APPLICATION NO.	FILING DATE	FIRST NAMED INVENTOR	ATTORNEY DOCKET NO.	CONFIRMATION NO.
10/566,221	09/20/2006	Hajime Nagai	1176/309	5690
46852 LIU & LIU	7590 03/21/200	8	EXAMINER	
444 S. FLOWE LOS ANGELE	R STREET, SUITE 1750)	TRAN, THIENVU V	
LOS ANGELE	5, CA 900/1		ART UNIT	PAPER NUMBER
			2819	
			MAIL DATE	DELIVERY MODE
			03/21/2008	PAPER

Арі	olication No.	Applicant(s)	Applicant(s)				
		10/	566,221	NAGAI, HAJIME					
Office Action Summary			ıminer	Art Unit					
		THI	ENVU V. TRAN	2819					
	The MAILING DATE of this communication appears on the cover sheet with the correspondence address Period for Reply								
A SHORTENED STATUTORY PERIOD FOR REPLY IS SET TO EXPIRE 3 MONTH(S) OR THIRTY (30) DAYS, WHICHEVER IS LONGER, FROM THE MAILING DATE OF THIS COMMUNICATION. - Extensions of time may be available under the provisions of 37 CFR 1.136(a). In no event, however, may a reply be timely filed after SIX (6) MONTHS from the mailing date of this communication. - If NO period for reply is specified above, the maximum statutory period will apply and will expire SIX (6) MONTHS from the mailing date of this communication. - Failure to reply within the set or extended period for reply will

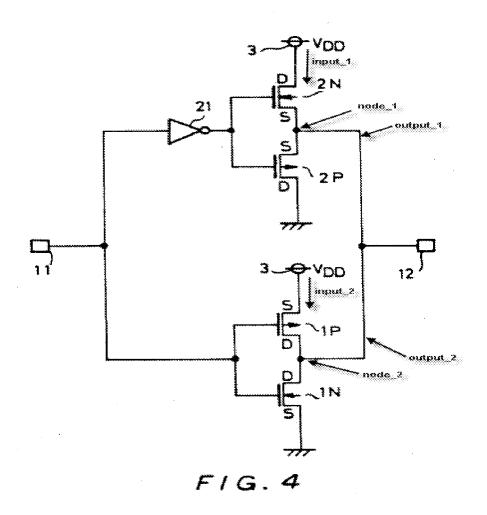
- (b) the invention was patented or described in a printed publication in this or a foreign country or in public use or on sale in this country, more than one year prior to the date of application for patent in the United States.
- 2. Claim 1 is rejected under 35 U.S.C. 102(b) as being anticipated by Aoki et al (U.S. Patent No. 5,192,879).

With respect to claim 1, Aoki teaches a converting device comprising:

a first input portion receiving a first input signal (e.g., input_1) (see fig. 4 below); a first output portion outputting a first output signal (e.g., output_1) (see fig. 4 below); a second input portion receiving a second input signal (e.g., input_2) (see fig. 4 below); a second output portion outputting a second output signal (e.g., output_2) (see fig. 4 below); and a voltage dropping circuit (e.g., circuit containing transistors 2N, 2P, 1N, 1P) (see fig. 4) dropping voltages on a first node (e.g., node_1) (see fig. 4 below) located between said first input portion and said first output portion to ground voltage (e.g., when a low signal appears at the gate of transistors 2N and 2P, transistor 2P will turn on and 2N will turn off, thereby placing the node *node_1* at ground) (see fig. 4 below) and on a second node (e.g., node_2) (see fig. 4 below) located between said second input portion and said second output portion to ground voltage (e.g., when a high signal appears at the gate of transistors 1N and 1P, transistor 1N will turn on and 1P will turn off, thereby

placing the node *node_2* at ground) (see fig. 4 below), before changing from a state in which said first input portion is disconnected from said first node to a state in which said first input portion is connected to said first node (e.g., the node *node_1* is connected to the first input portion based on the control signal asserting and de-asserting transistor 2N/2P) (see fig. 4 below).
